December 29, 2025

CONTRACT NO. 1797

OHIO RIVER TUNNEL

ADDENDUM No. 11

A58-ST-406 **ORT-A58-RG1 CONSTRUCTION SEQUENCING** SHEET 1 OF 3

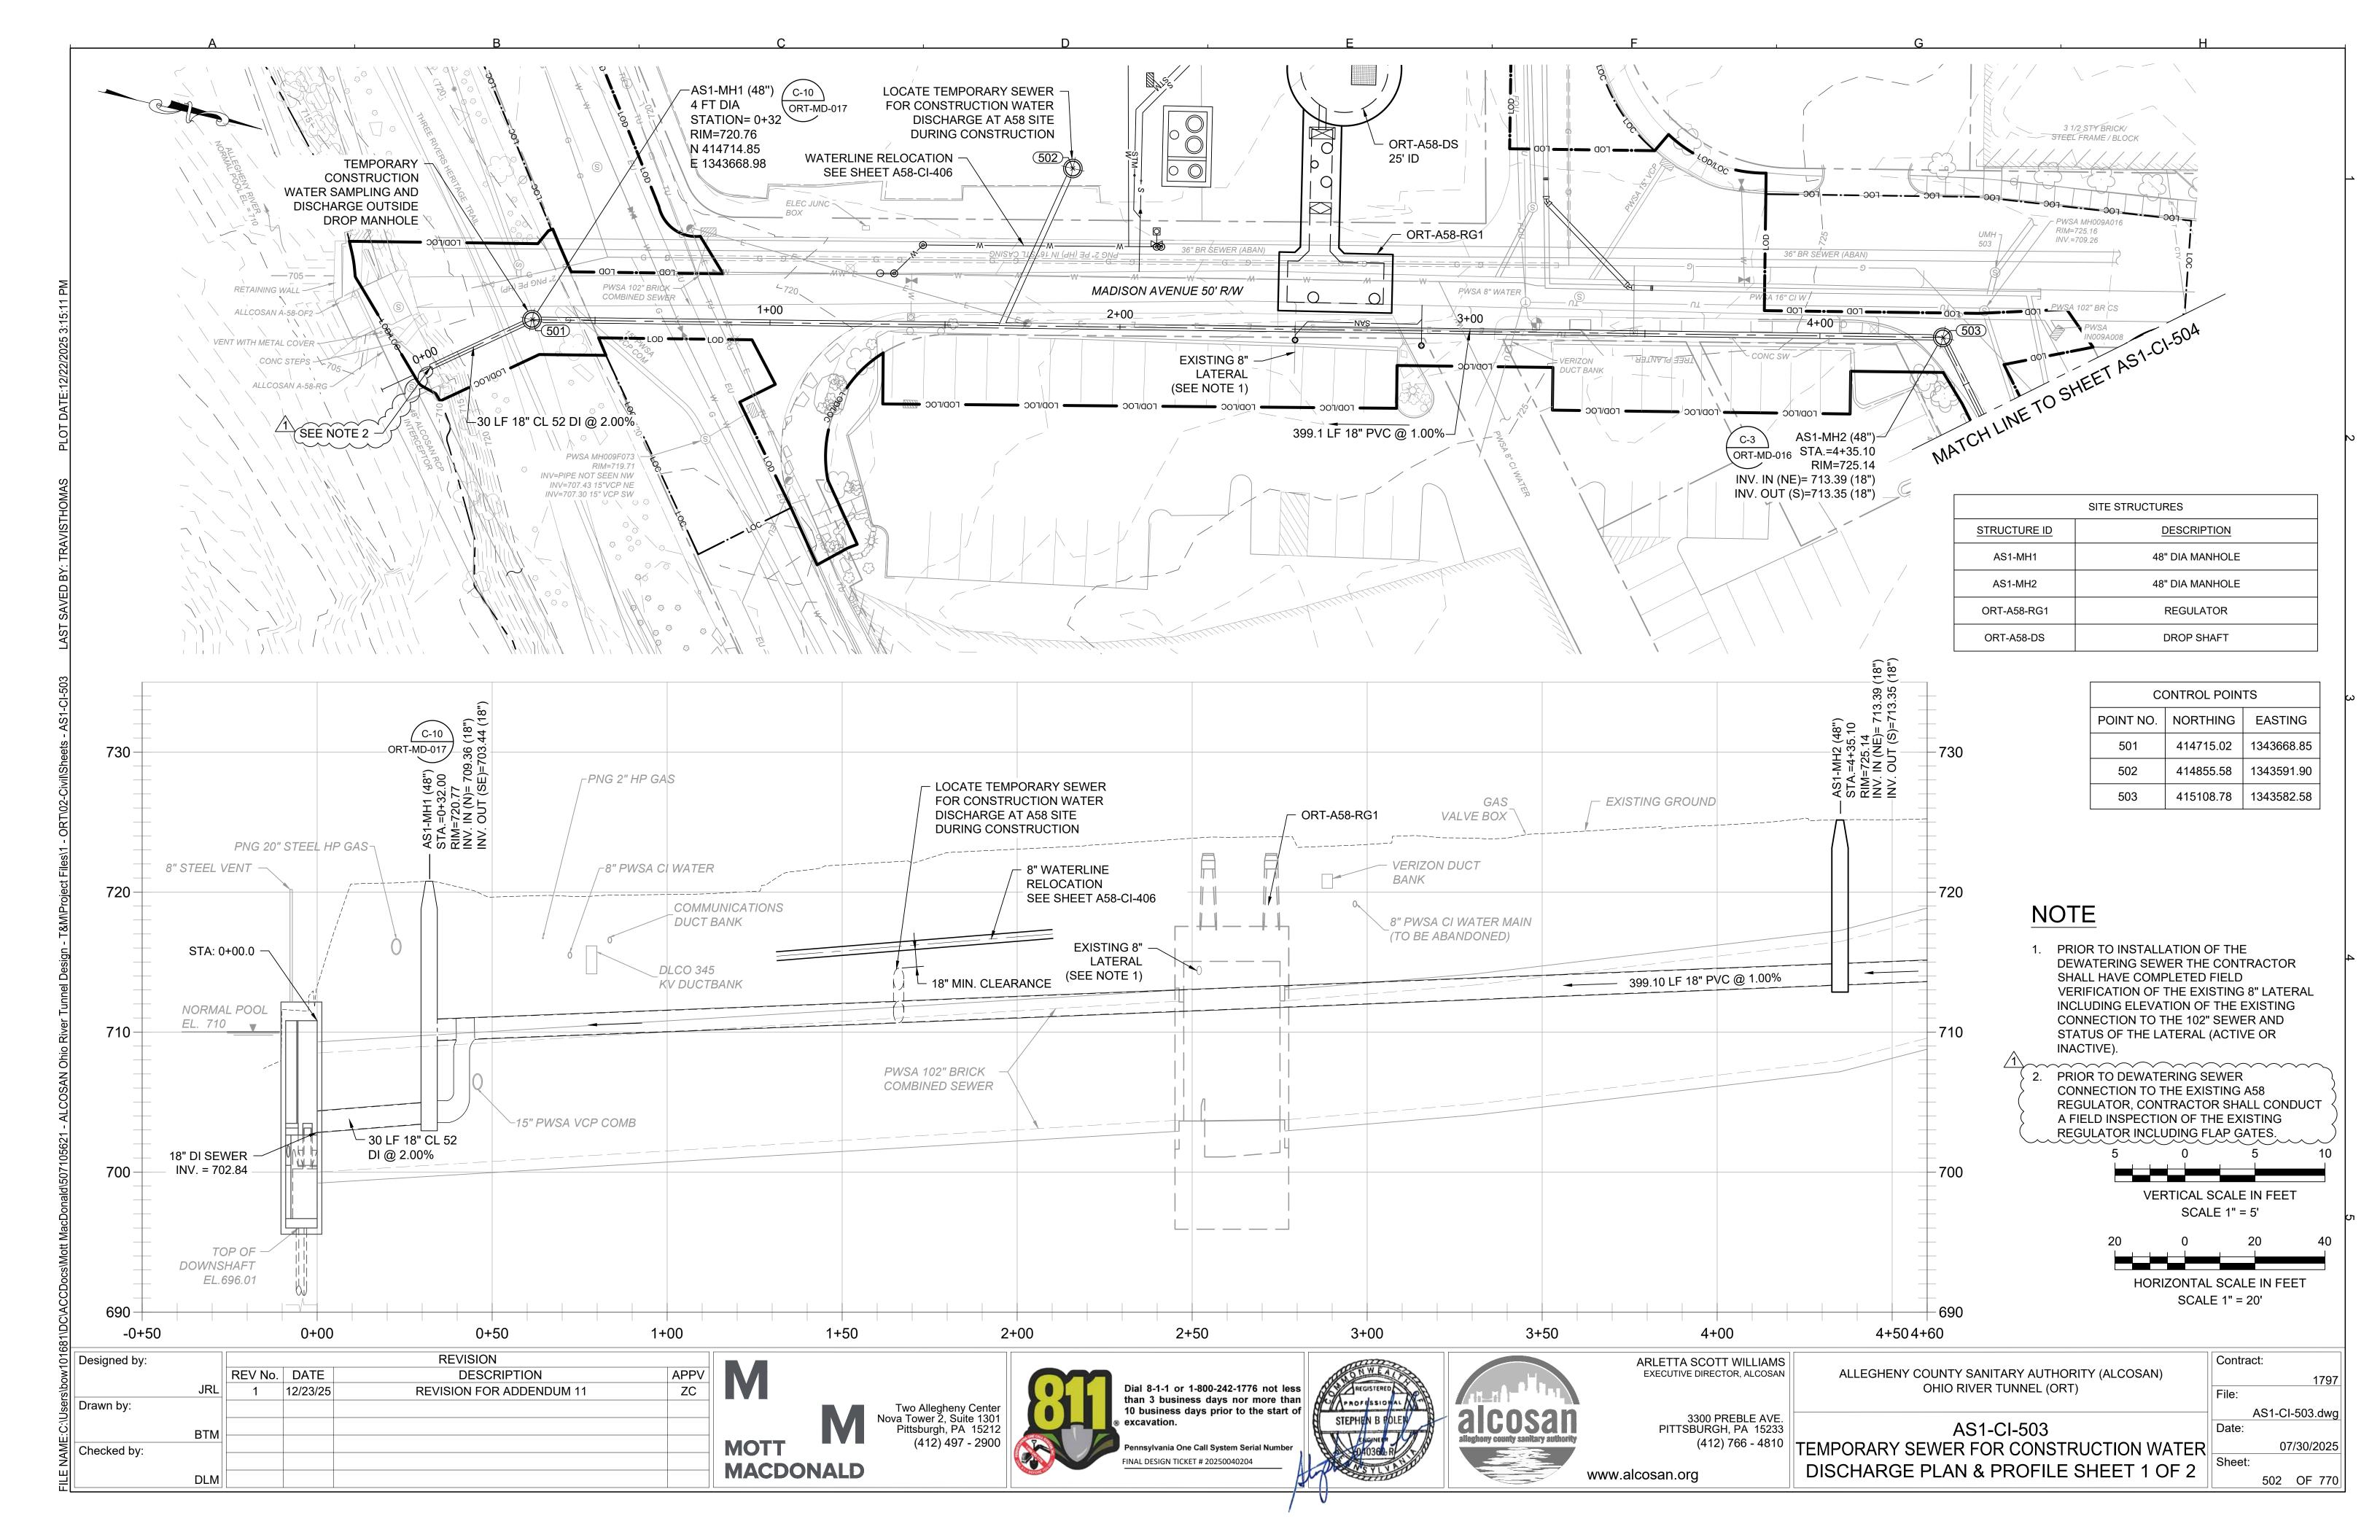
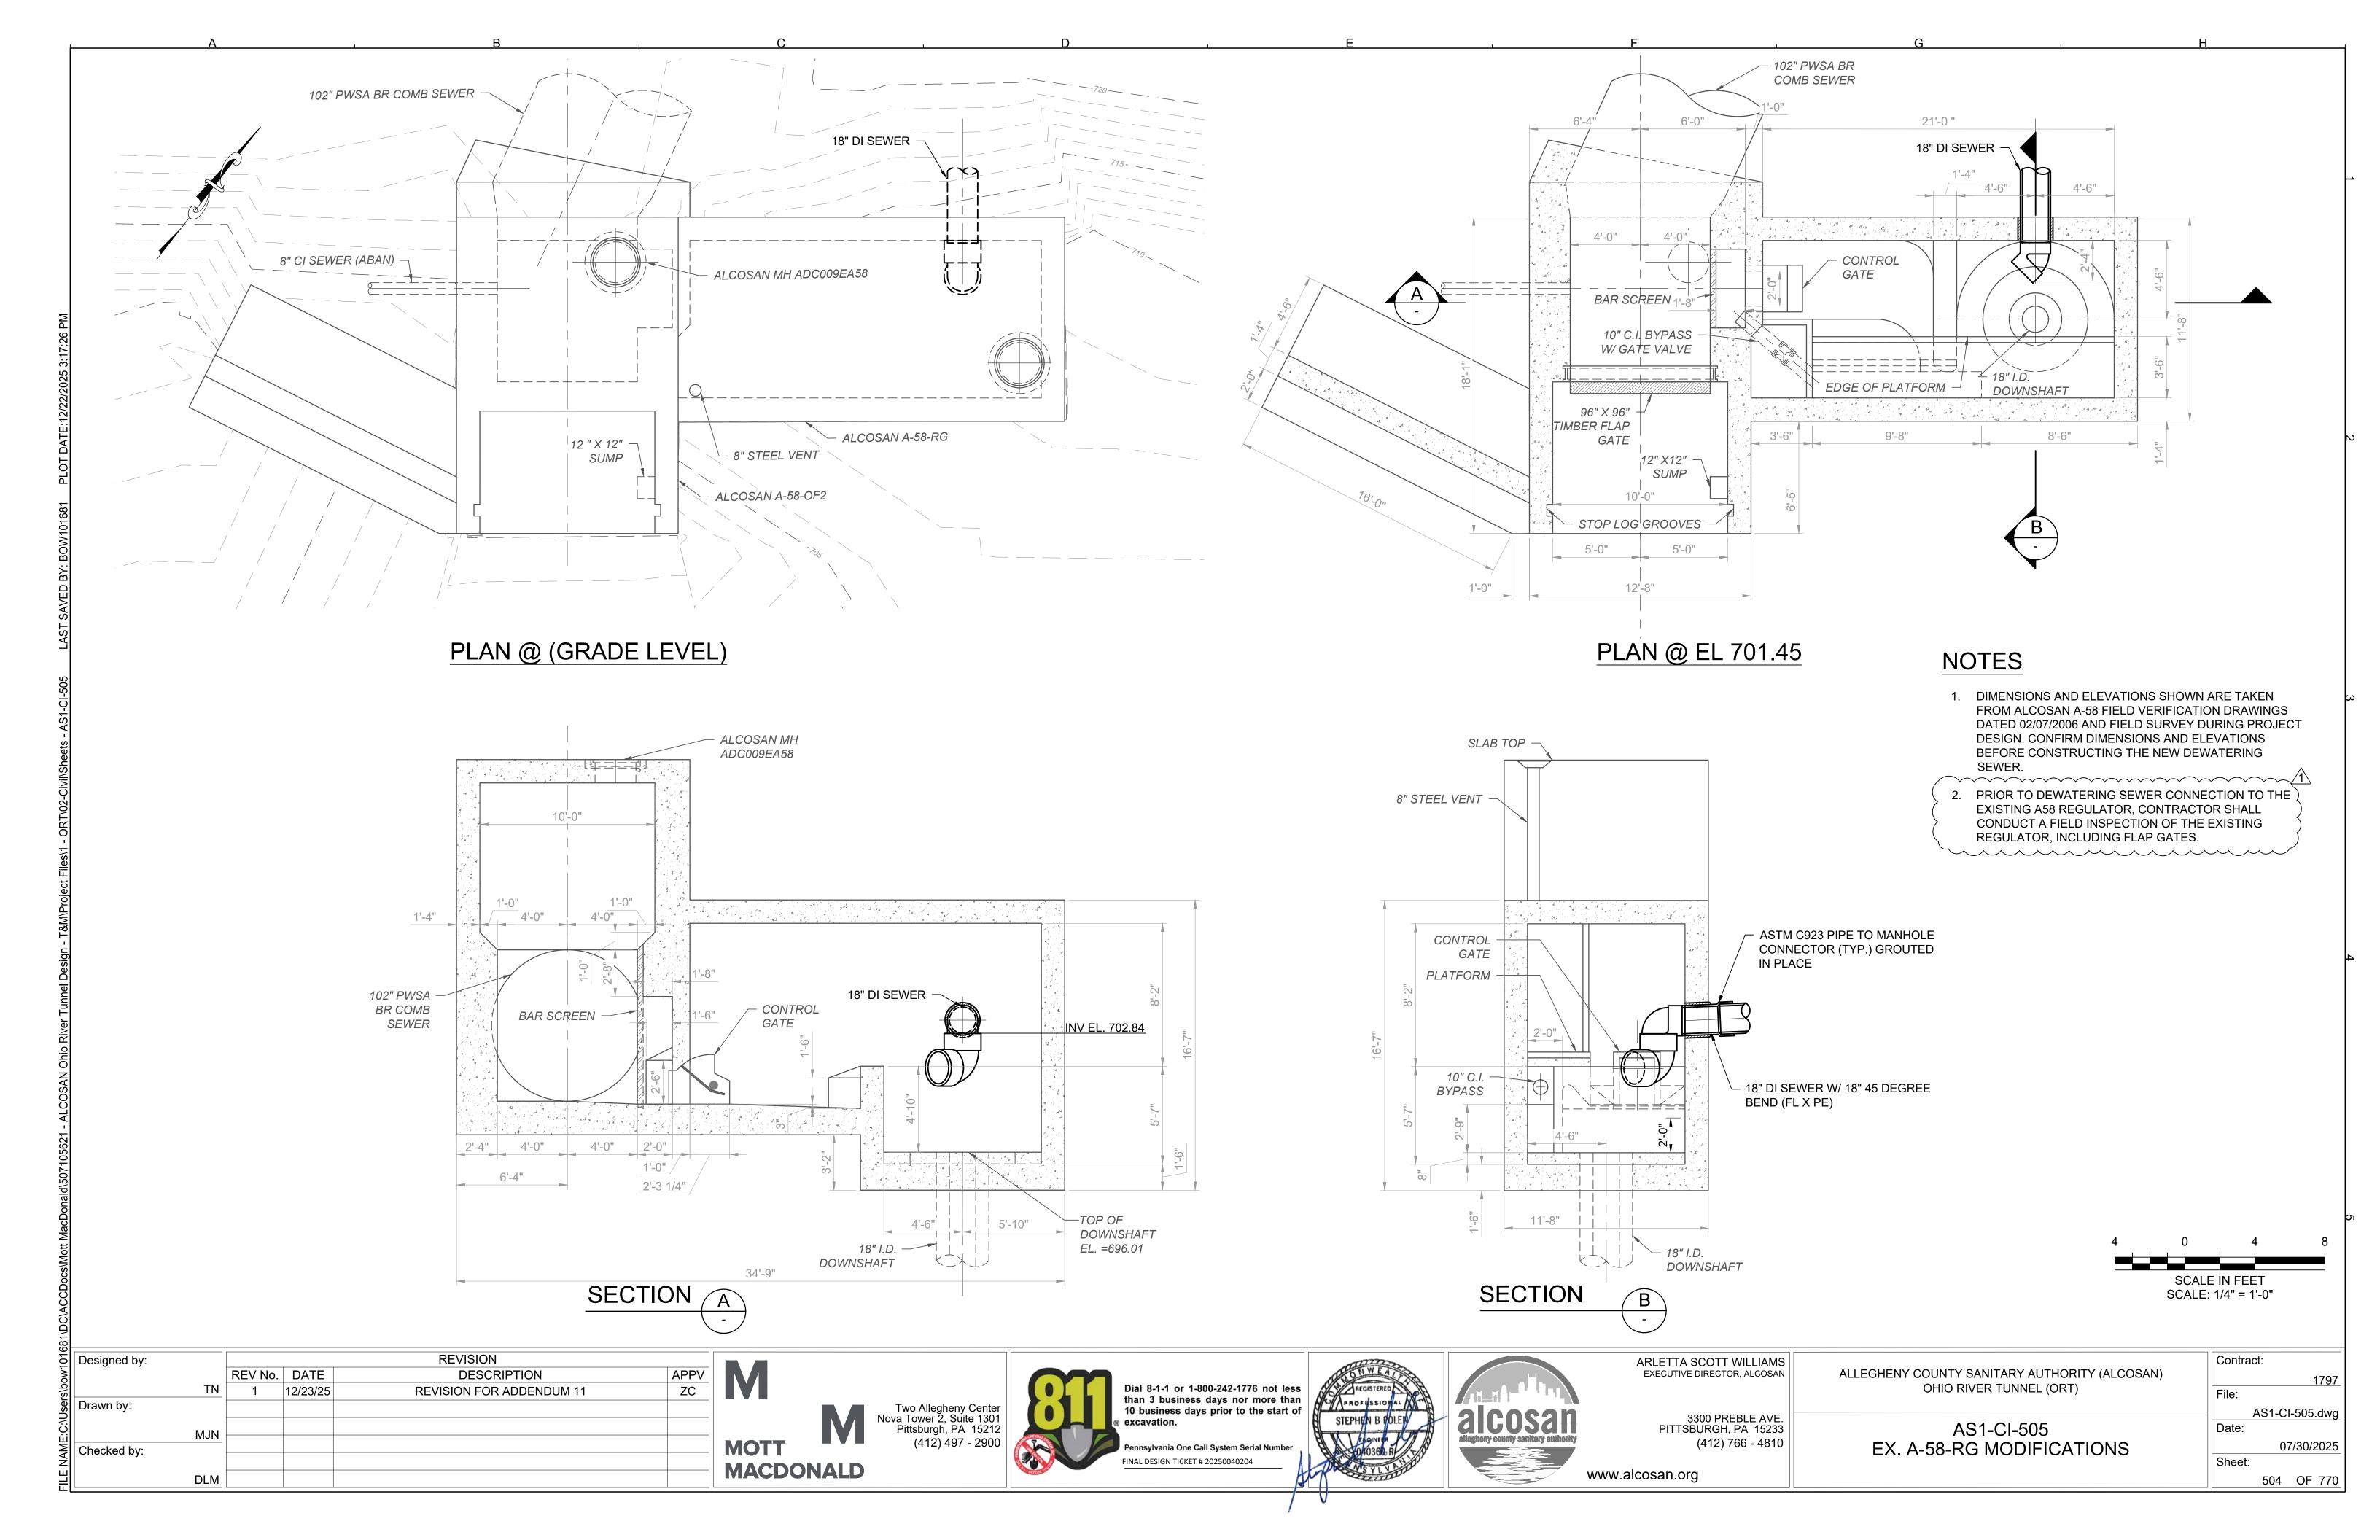
- A23 Inspection and repair requirements of the flap gate at A58 outfall have been ADDED to Section 01 22 00 (BID ITEM 39). Notes for this effort have been ADDED to Contract Drawings A58-ST-406, AS1-CI-503, and AS1-CI-505. See Section B Items 11 and 12, and Attachment F for Changes to Contract Documents.

• Revised O07-ST-701 (Sheet 590 of 770)

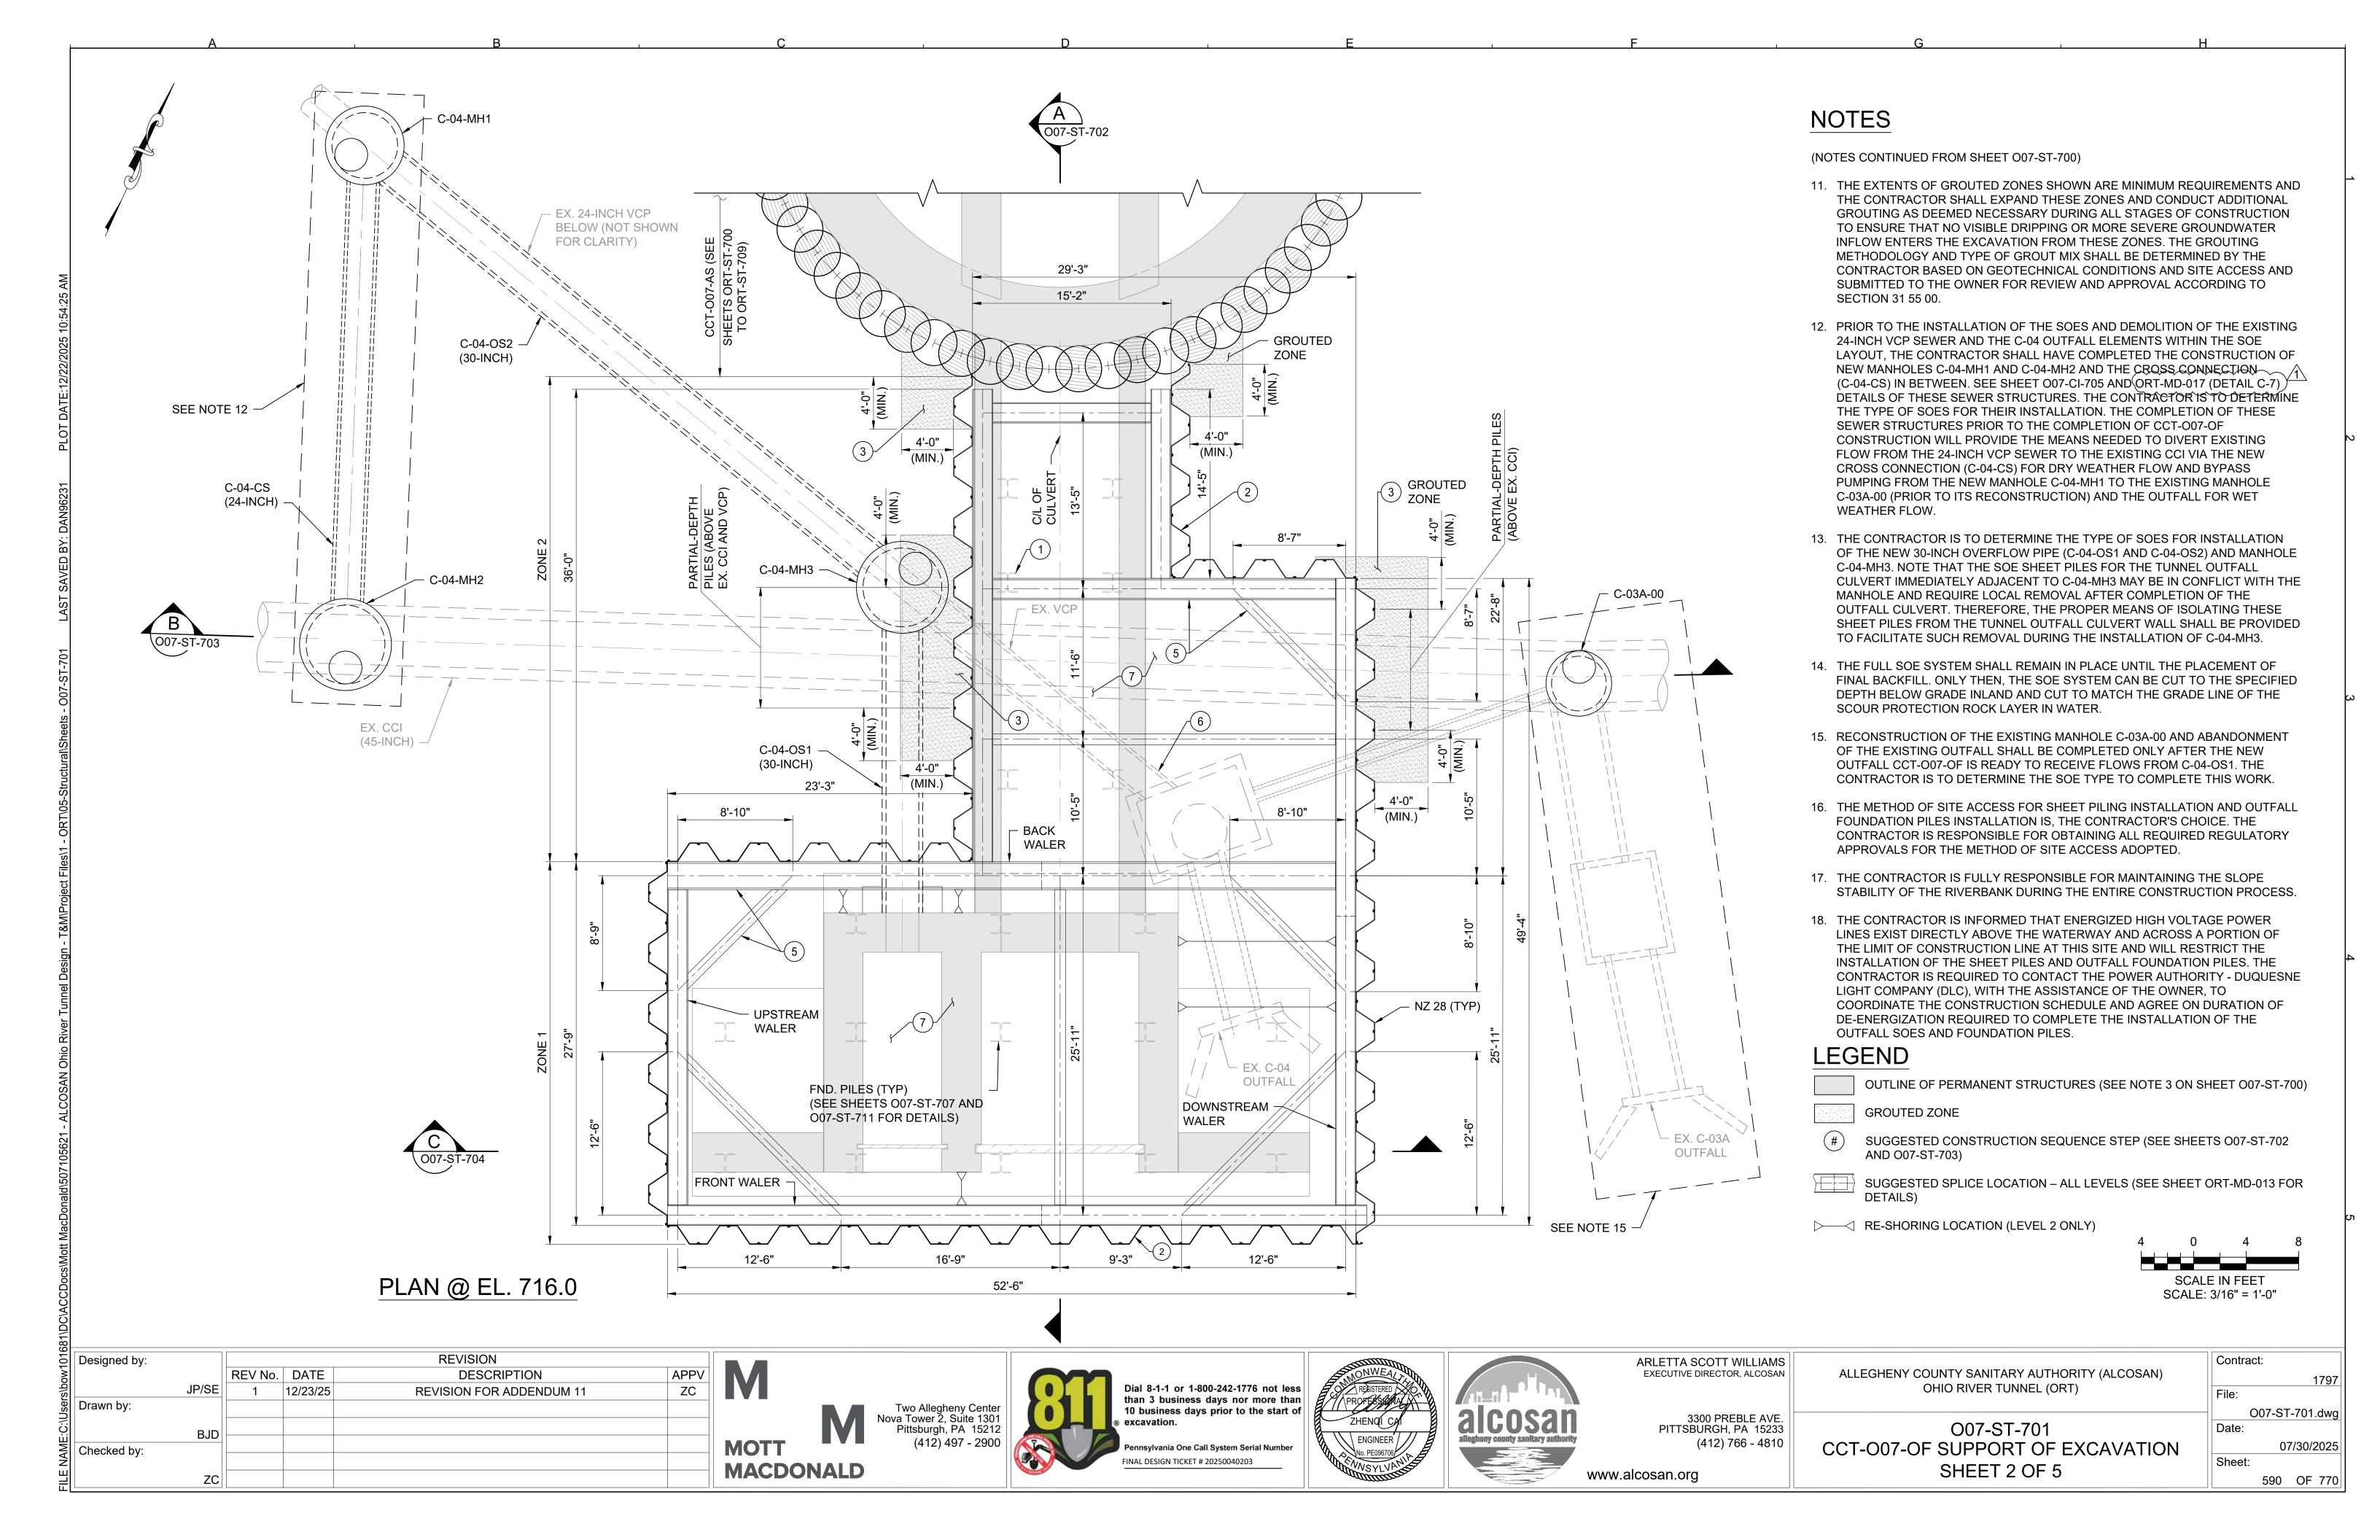
For clarification purposes, Section 02 73 40 Part 3.5.N (not 3.2.N as quoted in the RFI) addresses flow management operations at the O07 Site. In addition, Details of C-04-MH1/C-04-CS, and C-04-MH2 are shown on Sheet O07-CI-705 and Sheet ORT-MD-017 (Detail C-7), respectively. Note 12 on Sheet O07-ST-701 has been revised to include reference ORT-MD-017.
